Office Action Summary	Application No. 10/582,673	Applicant(s) INAGAKI, TOSHIYUKI	
	Examiner ASHLEY KWON	Art Unit 1795

DETAILED ACTION

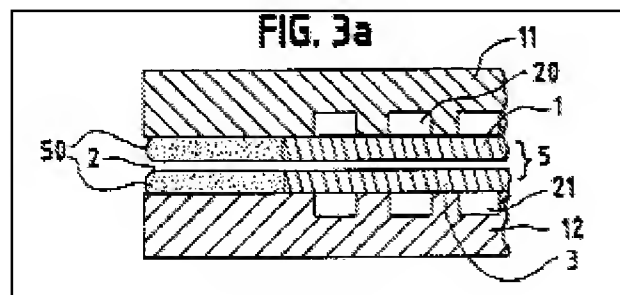
Regarding claim 27, Schmid discloses a fuel cell stack (see fig. 1) comprising: a pair of separators (11, 12); an MEA (5) in which an electrolyte membrane (2), a catalyst layer, and a diffusion layer (electrode layers 1, and 3) are laminated (see col. 1, lines 21-33), and which is provided between the pair of the separators; and an adhesive layer (50) provided between the pair of the separators, which contacts at least an end of the electrolyte membrane, an end of the catalyst layer and an end of the diffusion layer (see fig. 3a). Schmid discloses two possible MEA configurations, one where the membrane extends beyond the electrodes, and another where the membrane is coextensive with the electrodes (see col. 6 line 61 – col. 7, line 5). In both configurations the adhesive layer would contact at least an end of the membrane, catalyst layer, and diffusion layer.

Regarding claim 28, Schmid in view of Kye discloses the fuel cell stack according to claim 27, wherein; the electrolyte membrane has an extended portion which extends beyond the end of the catalyst layer and the end of diffusion layer (*Schmid*: see col. 6, lines 61-67), and a portion of the adhesive layer is provided between the extended portion of the electrolyte membrane and one of the pair of separators so as to contact a surface of the extended portion, and another portion of the adhesive layer is provided between the extended portion of the electrolyte membrane and another of the pair of

separators so as to contact another surface of the extended portion (*Schmid*: see fig. 3a). *Schmid* discloses that the catalyst layer is provided at the interface between electrode layer and the PEM layer (see col. 1, lines 26-30). Therefore, if the PEM is extended beyond the electrode layer, then it also would be extended beyond the catalyst layer as well.

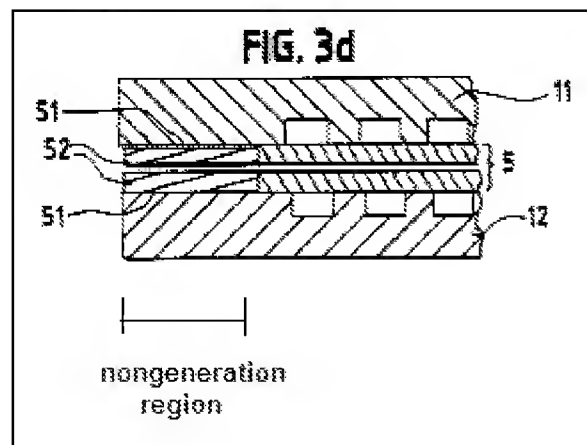
Regarding claim 32, Schmid in view of Kye discloses the fuel cell stack according to claim 27, wherein a rigid spacer (51) is provided in the adhesive layer (52) (*Schmid*: see fig. 3d). Schmid discloses that adhesive bonding agent could be an epoxy (see cp./ 5. ;oe 35-40), which are known to be hard substances.

Regarding claim 33, Schmid in view of Kye discloses the fuel cell stack according to claim 32, wherein the rigid spacer (51) is provided in the adhesive layer (52) throughout a non-generation region (see annotated fig. 3d).
